Model : GP605

Ref. No. : FF-T01-K1-000020-UK2

Location : ADF PICK-UP ASSEMBLY

Subject : MEASURES FOR THE FOLDING OF THE DOCUMENT'S LEADING EDGE IN THE ADF

Fig. 1

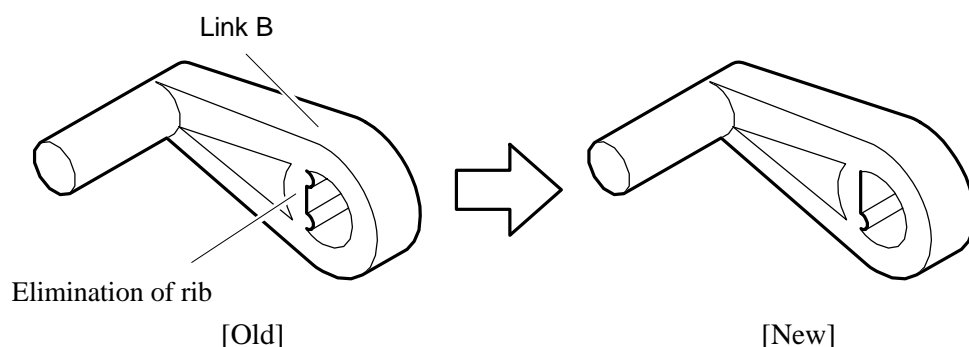
By eliminating the rib of link B (Parts Catalog TY8-31DV-000 page 30-97) and changing to the type with a different angle, the folding up of the reversing flapper was restrained, and the striking of the document against the copyboard glass prevented.

Fig. 5

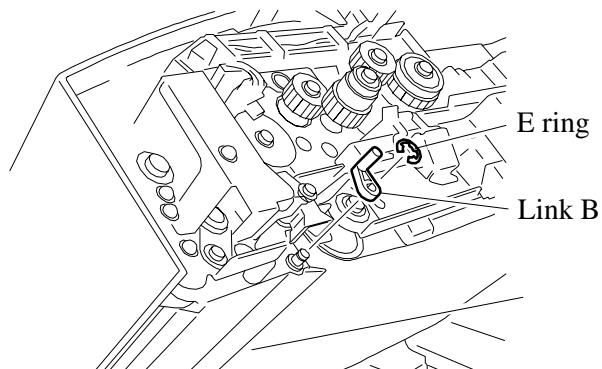
- 4) Remove the E ring, and replace link B (Fig. 5).

Fig. 6

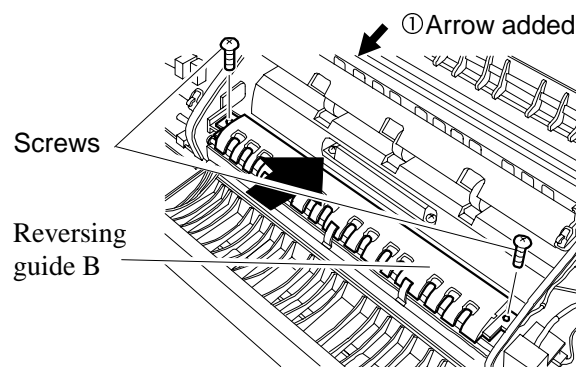
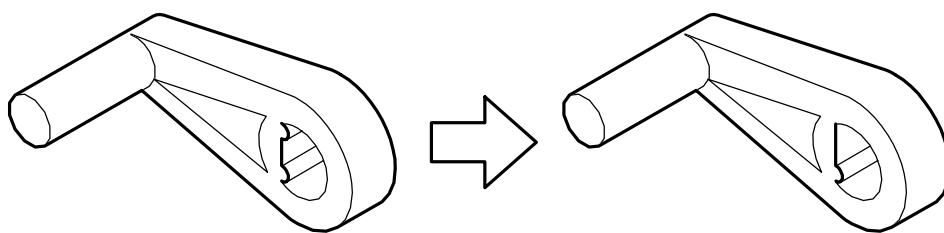
- 5) Open the registration guide, loosen the 2 screws and push in the reversing guide B in the direction of the arrow until properly seated, and then re-tighten the screws (Fig. 6).
